PRODUCT REFERENCE MEMO

40-77C AND 40-77E WHEEL ASSEMBLIES, TIE BOLT / OVERHAUL SET AVAILABILITY

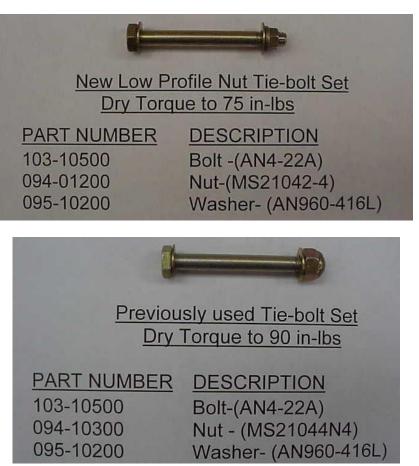
Review of the tie-bolt system found that under some conditions the standard AN hardware may not provide a minimum of one thread exposed above the nut as recommended by FAA AC 43.13-1B, Chapter 7, Pg. 7-11.

A low profile all metal lock nut is available that meets the suggested minimum of one thread exposed above the nut under all conditions.

The low profile nut will provide distinct visual indication of proper bolt engagement. Use of the existing nut is still an accepted configuration; however a different torque value is required.

- 7. Reassemble wheel per maintenance manual instructions installing one (1) washer under each nut and DRY torque nuts in two steps; first to 35 in-lbs then to 75 in-lbs. ALWAYS restrain the bolt head and torque the nuts until all nuts are properly torqued. Lubricant is **NOT** to be used.
- 8. Place Warning label adjacent to valve hole.
- 9. Place identification label opposite valve hole.
- 10. Reinstall wheel on aircraft per applicable aircraft manual.
